### **ASC Meeting Minutes November 18, 2020**

#### **Unit 07, Lot 088**

#### **Submittal: House/Garage 2485SF**

**DECISION LETTER  
ARCHITECTURAL STANDARDS COMMITTEE**

WEST ELEVATION  
SCALE 1/4" = 1'-0"

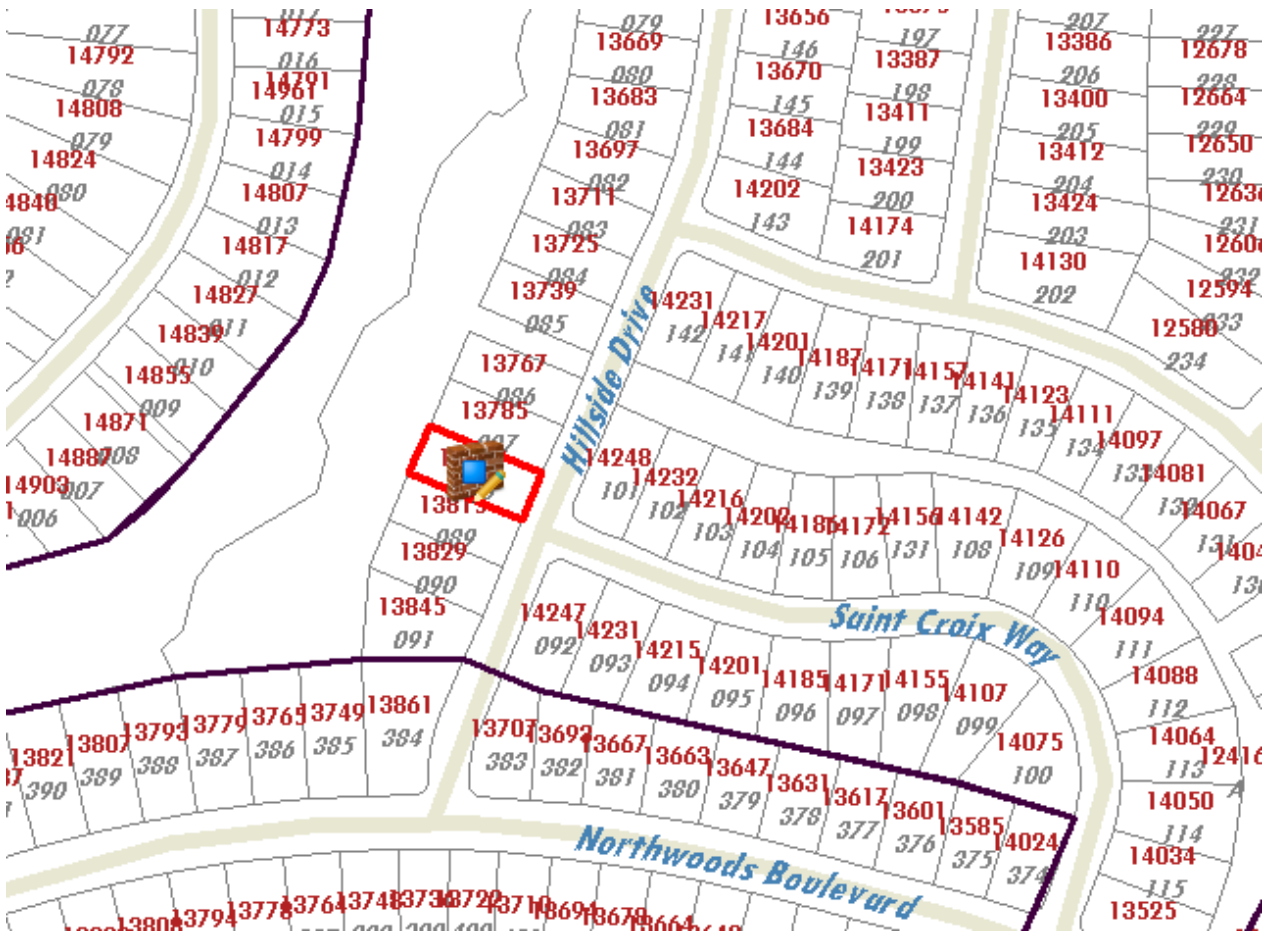
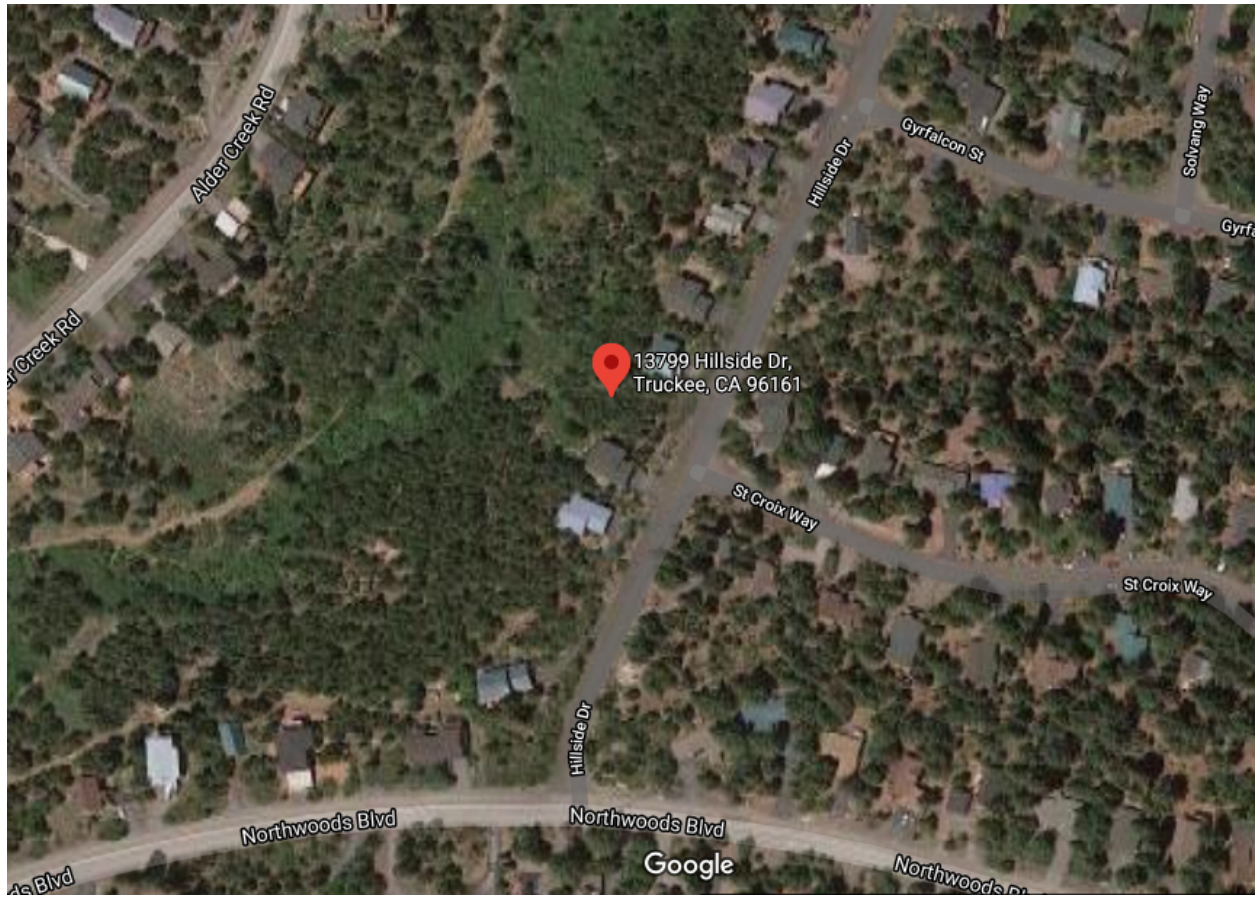
- The committee reviewed the exterior specifications, including the roofing, window materials and finish colors, were approvable as proposed. The committee reviewed the proposed siding exceeding 50% sheet siding on the rear elevation. The committee requires a revision to adjust the siding prior to permit issuance as the sheet siding exceeds 50% on the rear elevation and can be reviewed as a one-member weekly revision.

- The committee explained the light is approvable however suggest a warm color up to 3500K.
- The committee discussed the direct vent for the house to be shown on the elevation plan as a revision.

Greater than 50% Sheet Siding on Rear Elevation

I would like to request the committee reconsider the 50% sheet siding rule on the back elevation of my home. Upon reviewing page 12 of the ASC rules this clearly states an exception is allowed when not in view from the street or golf course.

- The committee stated the owners may appeal any decision to the Board of Directors.
- Action 3:0 (Whitten, Phelps, Hipkins). The project was conditionally approved based on a siding revision to reduce sheet siding below 50% on the rear elevation, adding the direct vent to the elevations, and an approved site inspection.]

SITE PLAN

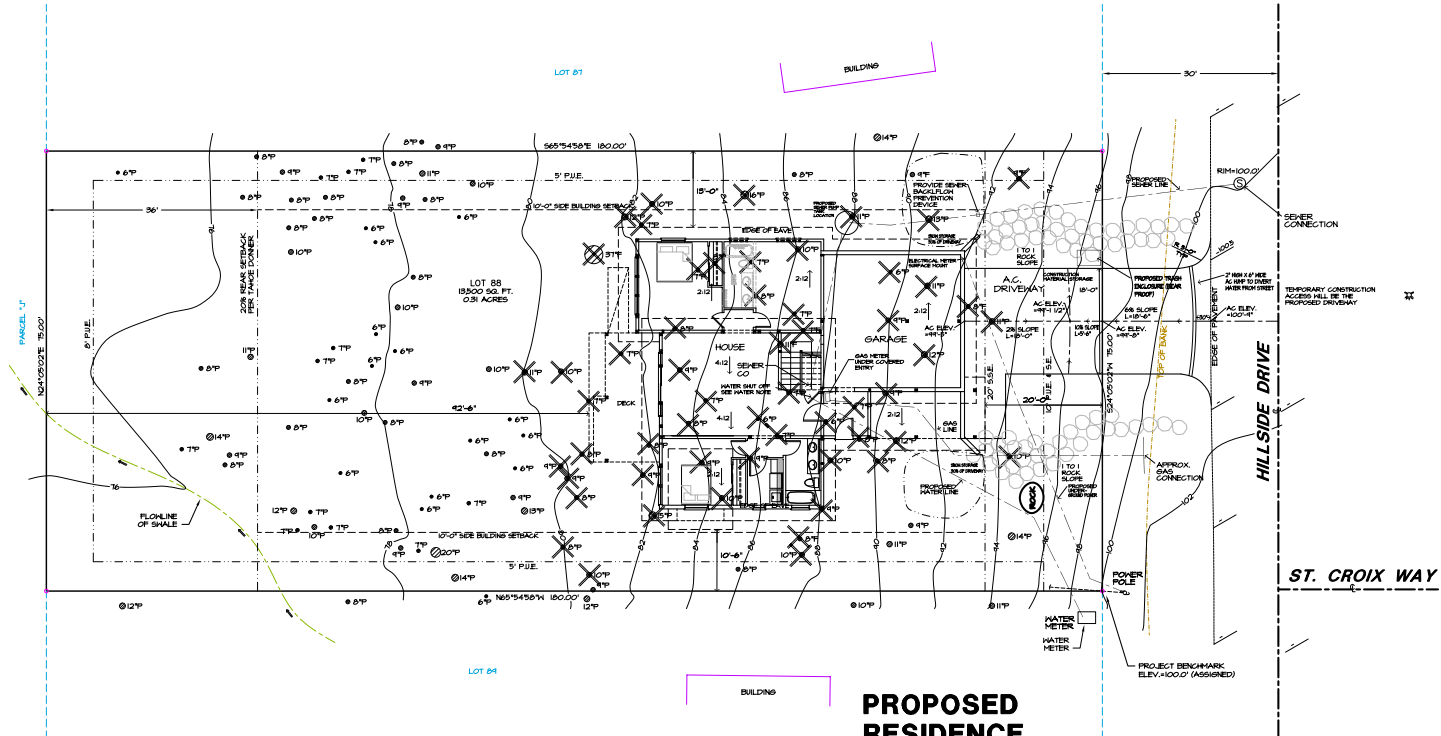
- The committee reviewed the site plan discussed the coverage percentage at 22%.
- The committee reviewed the proposed tree removal, the utility lines and noted the power will be underground. The committee reviewed the excess proposed tree removal and the trees more than 10ft from the foundation and 5ft from decks must be approved from the Forestry department. The committee agreed that the 9"P and 10"P on the left near the property line, the 11"P beyond the rear deck, and 9"F at the front right of the property are not approved to be removed by the committee.

- There was one neighbor comment from Lot 89 was present and requested attendance. The neighbor explained concerns with proposed tree removal including the 10" F in the left side setback. The committee explained that tree is within 10ft from the foundation of the house and can be approved to be removed with the project. The neighbor requested to flip the floor plan of the house to place the garage on the southern side of the property versus as proposed with the garage on the northern side. The neighbor also inquired about the new construction hours and project start date; however, without a site inspection conducted yet and with snow on the ground, it looks like it will be a spring start.
